EASTERN CONNECTICUT ENVIRONMENTAL REVIEW TEAM REPORT

**WALKLEY HEIGHTS
SUBDIVISION**

**HADDAM
CONNECTICUT**

**REVIEW DATE: APRIL 17, 1990
REPORT DATE: MAY 1990**

TOPOGRAPHIC MAP

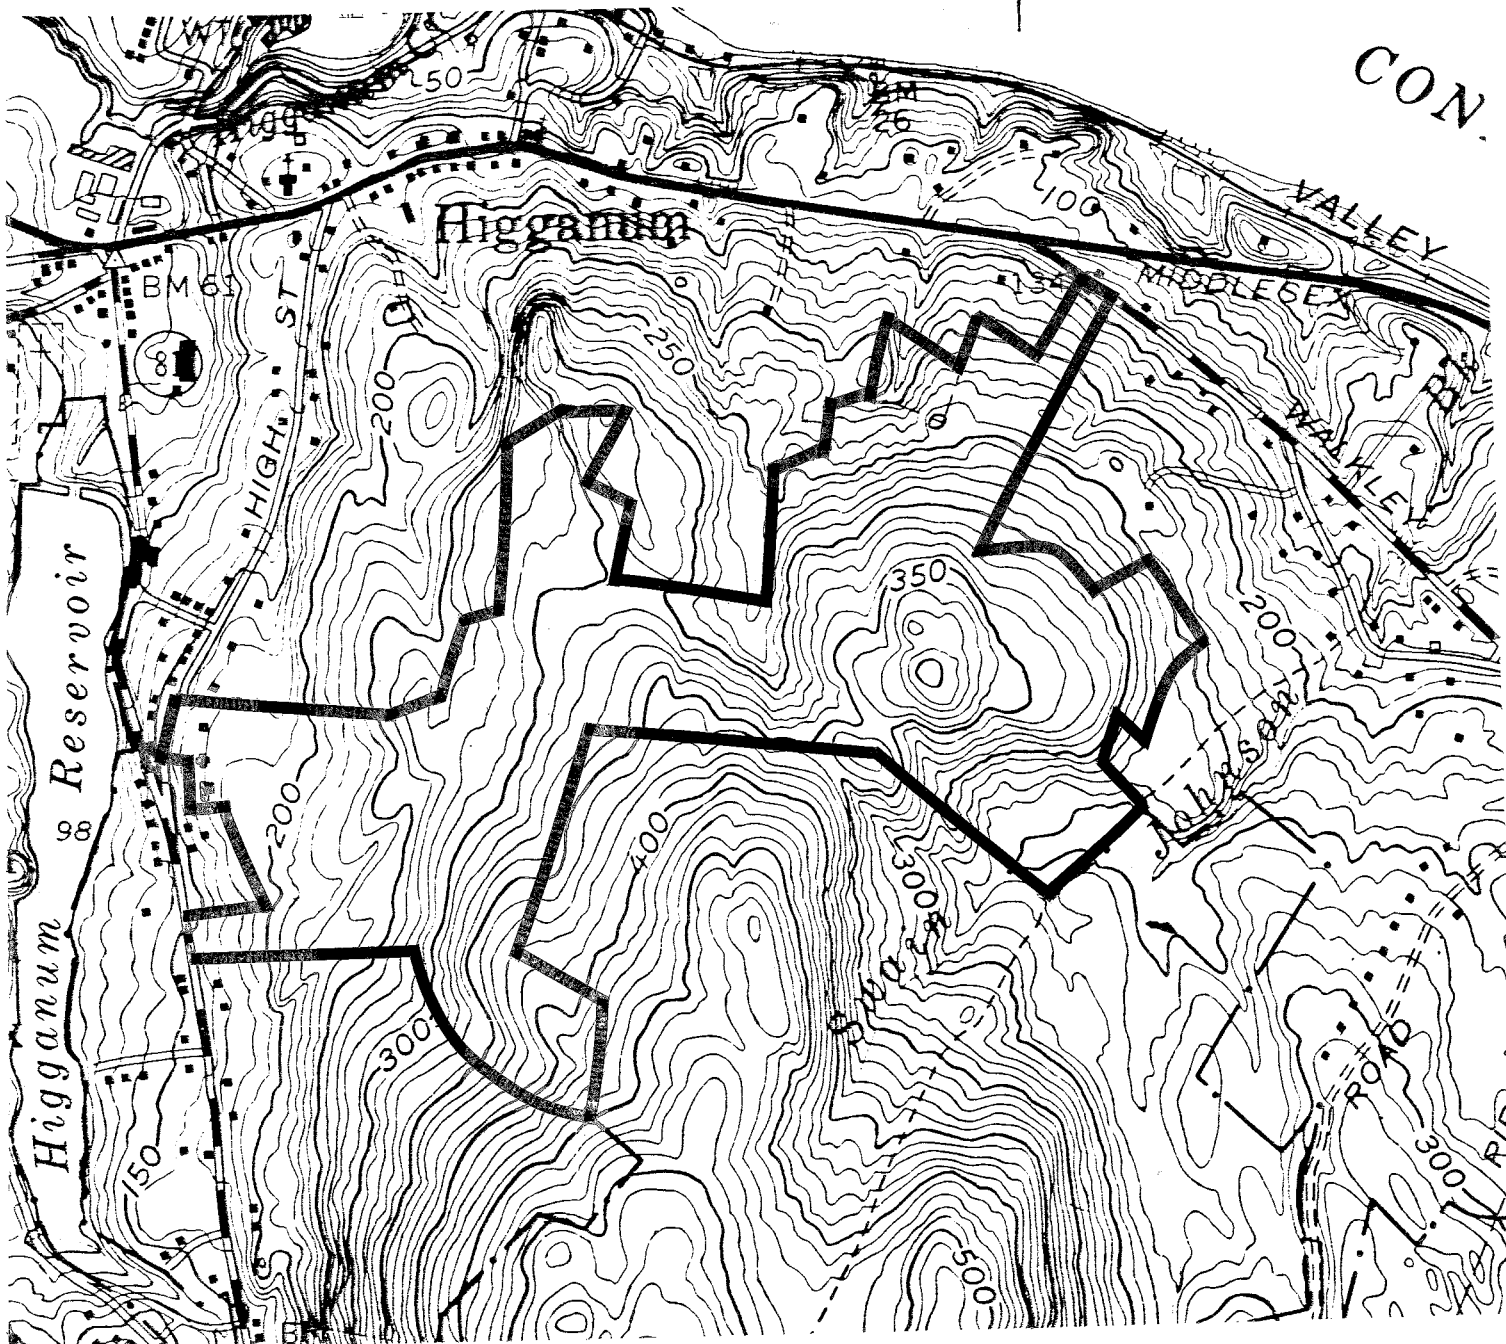
The proposed subdivision has been laid out so that new roads would avoid the steepest areas. One major exception is the segment of Granite Springs Road near proposed Lots 34, 35, 45 and 46 which will require a substantial earth/rock cut. A ± 13 foot cut is anticipated for the area. The remainder of the new road appears to have been designed to cross slopes and conform to the topographic contours rather than crossing perpendicular to the hilly areas on the site.

There is a good possibility that the ± 13 foot earth/rock cut mentioned in the preceding paragraph will encounter resistant bedrock which requires blasting. All blasting should be performed by persons familiar with the latest technology in blasting and the necessary measures taken to reduce the

chance for seismic shock and airblast. Also special care should be taken to ensure that leaching fields are not located too close to "cut" embankments for roads and driveways. The concern here is that partially treated effluent may bleed out at the cut embankment causing a public health nuisance condition. A minimum 50 foot setback is recommended between the cut embankment and any part of the leaching system.

WATERSHED BOUNDARY MAP

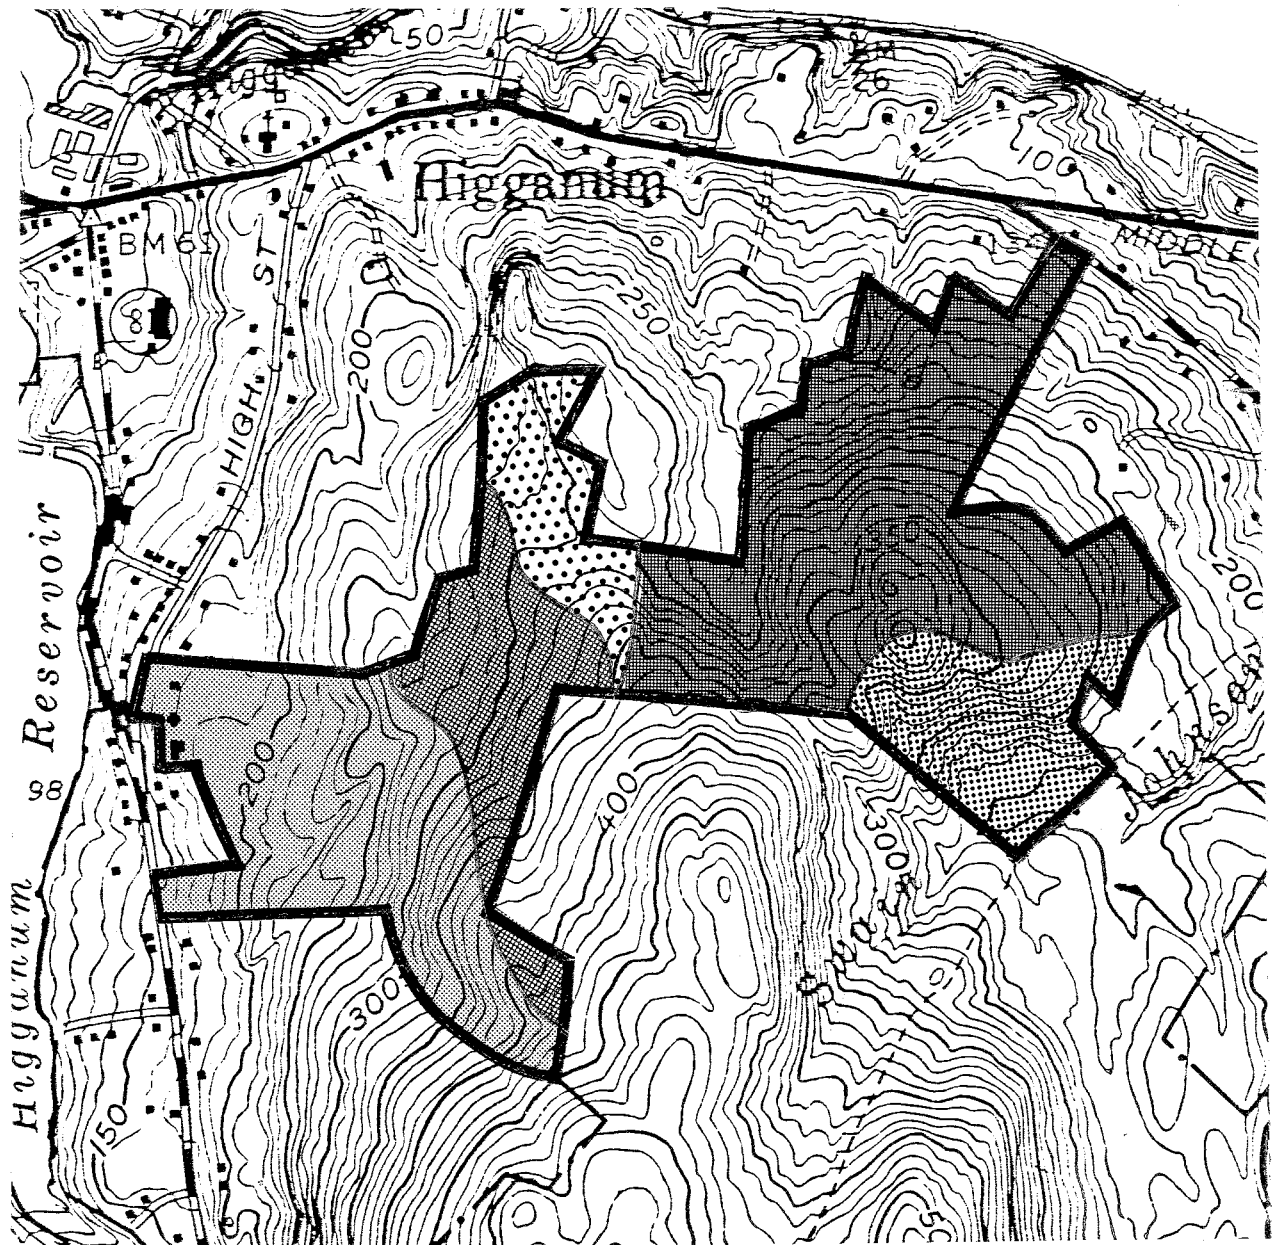
Subdivision of the property as planned will increase runoff from the site. In order to thoroughly assess the impacts of post-development runoff, the applicant should prepare a stormwater management plan. This information was not available. The plan should include all pre- and post-development runoff calculations as required by Town regulations. The Connecticut Guidelines for Soil Erosion and Sediment Control should be used as a guide.

Once this work has been completed, Town officials should evaluate the effects of post-development runoff on flooding and streambank erosion/surface water degradation. Every effort should be made to protect Higganum Reservoir and the other surface water bodies on and off the site. A narrative report, which states the initial conditions and storm frequencies to be analyzed, should accompany the stormwater management plan. A summary table showing the pre-development post-development and design system peak discharges for all design frequencies should also be included. An examination of existing and proposed downstream culverts is warranted for each subwatershed area. Also, if detention basins are required to avoid net increases in peak flows discharging from the site, this information should also be included in the stormwater management plan. As discussed earlier, in-stream basins are not recommended since they may cause temperature increases in streams, which negatively impacts aquatic life.

The physical condition of the dam impounding the man-made pond in the western parts is unknown. The DEP Bureau of Water Management Flood Control (Dams) sections should be contacted to determine if the dam is registered and if any information exists regarding its physical condition, especially if it is to be used for stormwater management purposes. The potential impacts to downstream areas, including the proposed subdivision, that would be inundated by a dam break, should be determined.

VEGETATION MAP

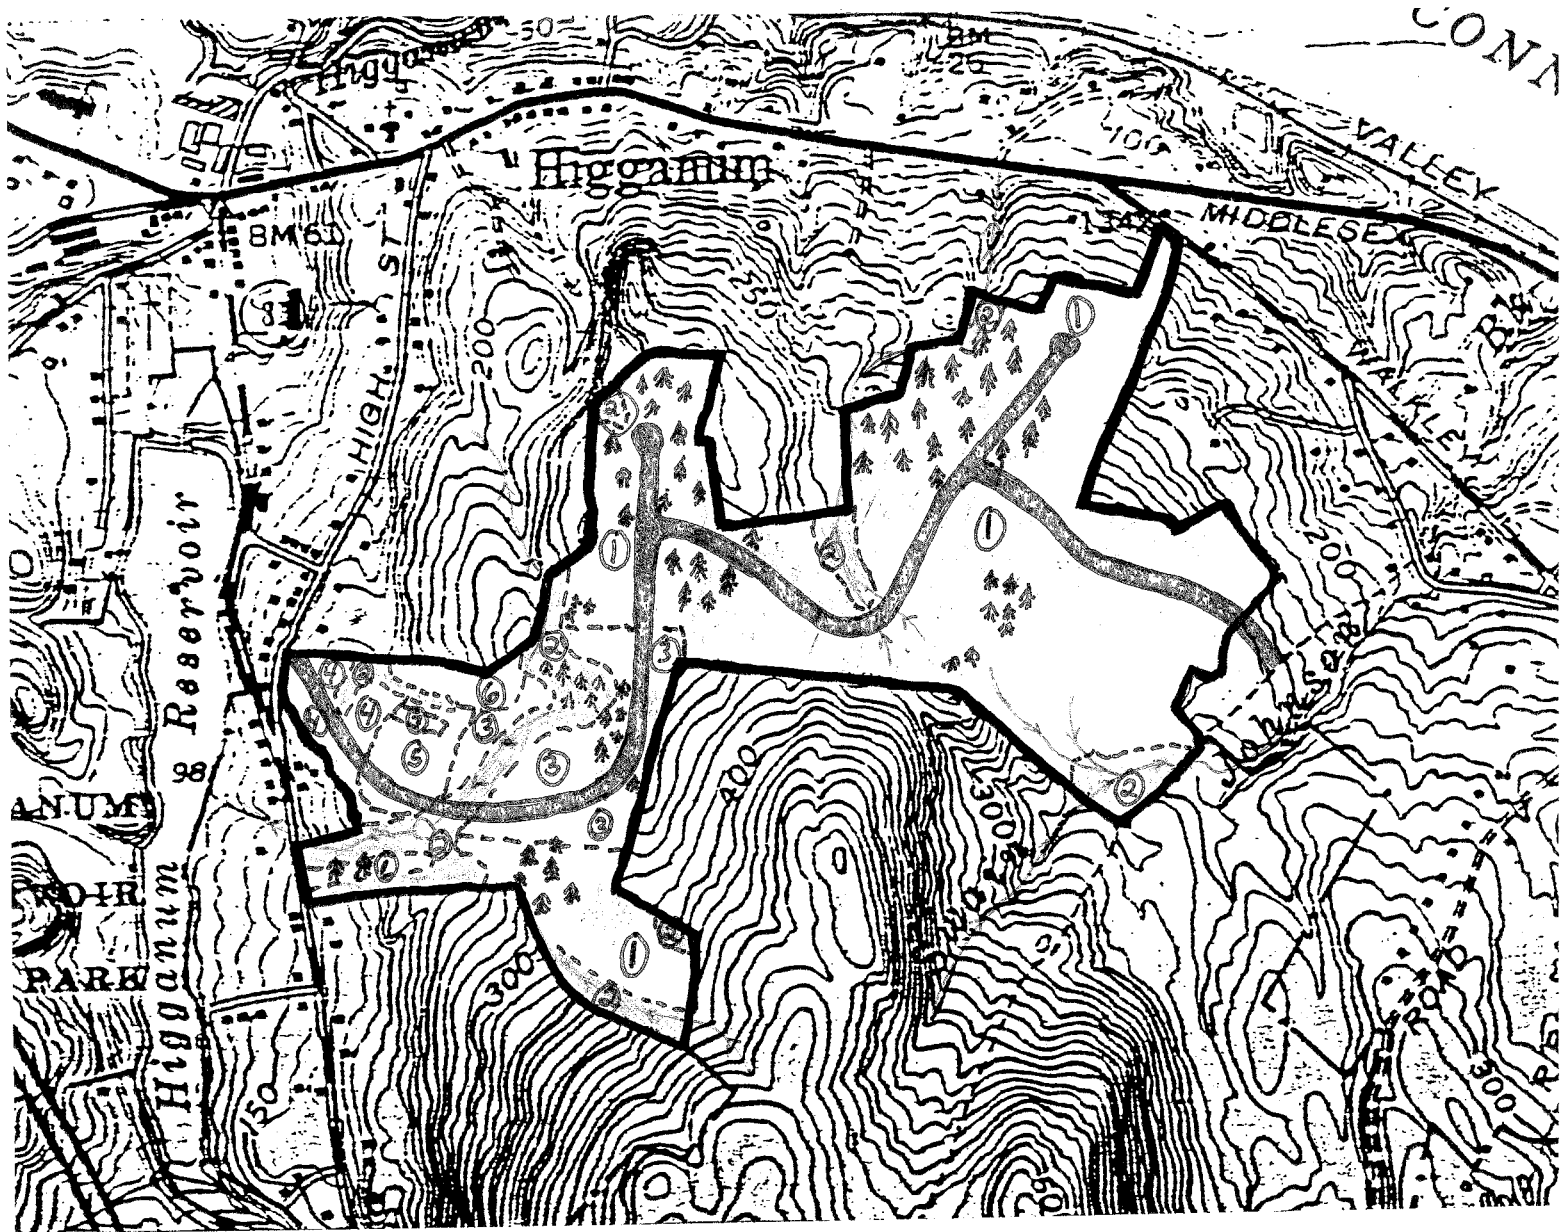
At this time hemlock are scattered throughout approximately 30% of the property. All of the trees which were sampled regardless of size or location were moderately to heavily infested with the Hemlock Woolly Adelgid. This scale-like insect which is relatively new to the area, may cause mortality in hemlock within several years, however the evidence which points toward mortality is not conclusive. The adelgid does however create needle loss in varying degrees which at the very least stresses the trees. Stressed trees are much more susceptible to secondary insect and disease organisms which also may cause mortality. Control of the Hemlock Woolly Adelgid has been successful using a wide variety of insecticides. Relatively non-toxic insecticides such as insecticidal soap which suffocates the insect have proven very effective on individual trees where complete soaking is feasible. Stands of larger trees will be almost impossible to treat in this manner effectively.

Potential hazards throughout the property include dead trees, dead tree parts and those trees whose roots or trunks have a high probability of failing due to excessive decay or lean. These trees become hazard trees if there is a high risk of injuring people or damaging property. All trees with the above-mentioned characteristics would be hazards if located within striking distance of a building or along areas of high use such as hiking trails or roads.
